Director – Transport Assessment, Planning and Assessment  
NSW Department of Planning, Industry and Environment  
Locked Bag 5022  
Parramatta NSW 2124

**Re: Northern Beaches Link and Gore Hill Freeway Connection  
Environmental Impact Statement**

Image #1: Reserve Rd traffic suggestion

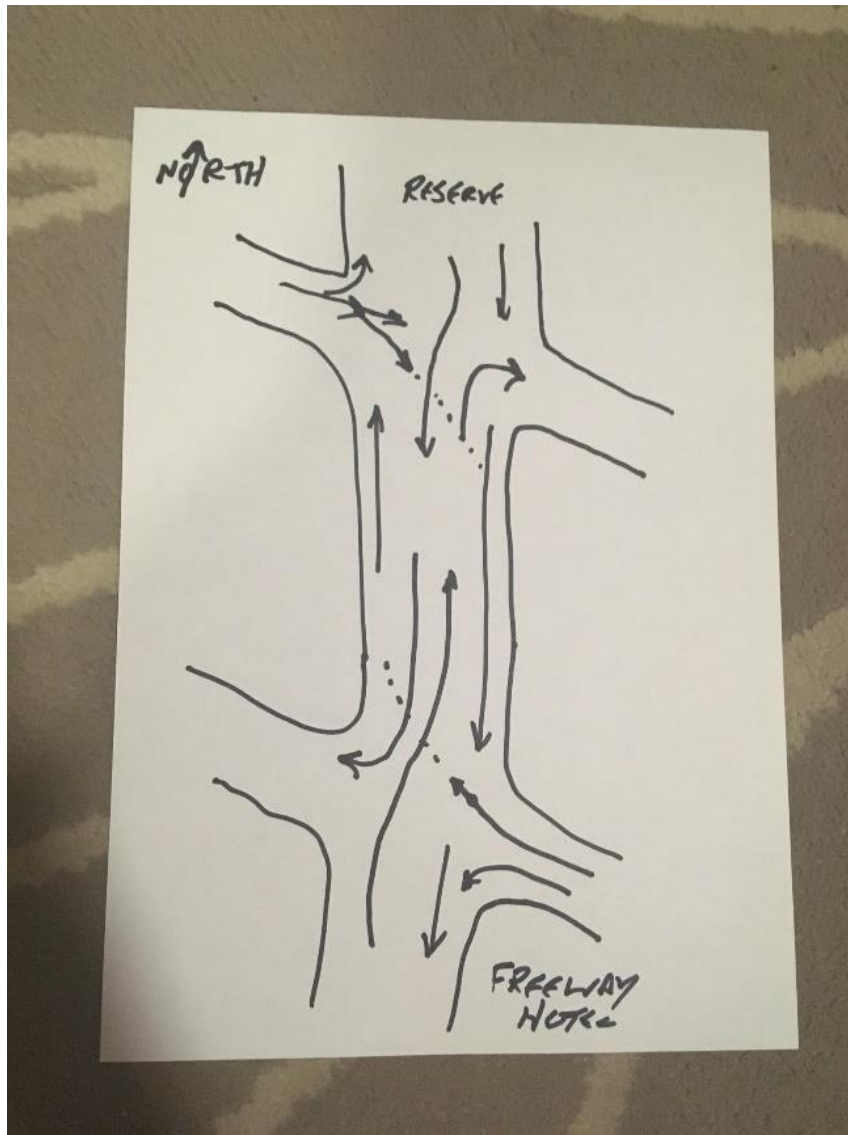
The existing problem with the Reserve Road intersection is that north bound turning right (city bound) and south bound turning right (Lane Cove bound) both crossing paths meaning if one gets to move the other one does not. Usually this means north bound traffic gets to move as it has more trucks which cars will give way to and trucks can also block physically the southern intersection and visually vehicles approaching in the southern left turning or straight lane thus stopping south bound flow.

To alleviate this issue my suggestion is remove part of this cross over issue. Please forgive the crudeness of my diagram. (Image #1: Reserve Rd traffic suggestion)

A search of the internet tells me that this (Image #1 & #2) traffic intersection arrangement is a Contra Flow with Right Turn.

Image #2 - Source [https://commons.wikimedia.org/wiki/File:AS\\_CFL.svg](https://commons.wikimedia.org/wiki/File:AS_CFL.svg) (reversed)

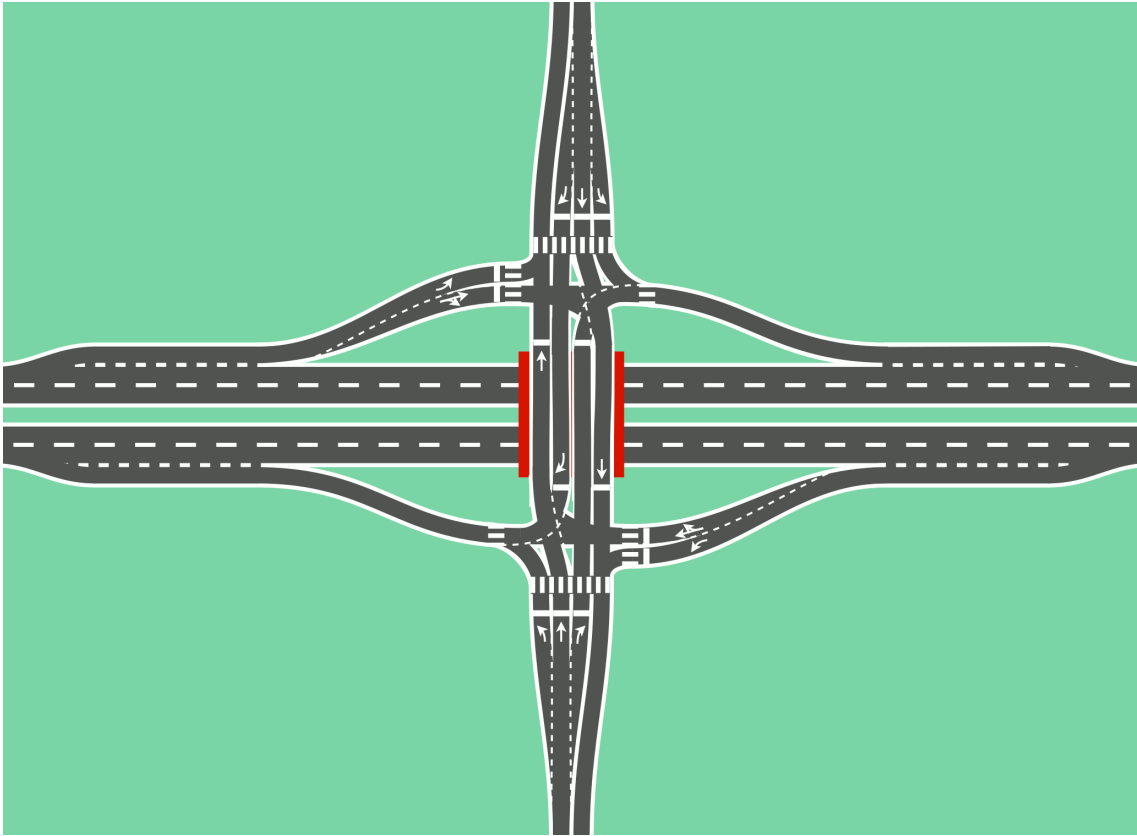
One can see the similarities between the above diagram (Image #2) and the existing Reserve Rd bridge intersection.

Any solution for this intersection needs to include consideration of the existing roundabout on Barton Rd as this provides a limited in peak hour south bound traffic flow and as such also limits departing traffic north bound in peak times.
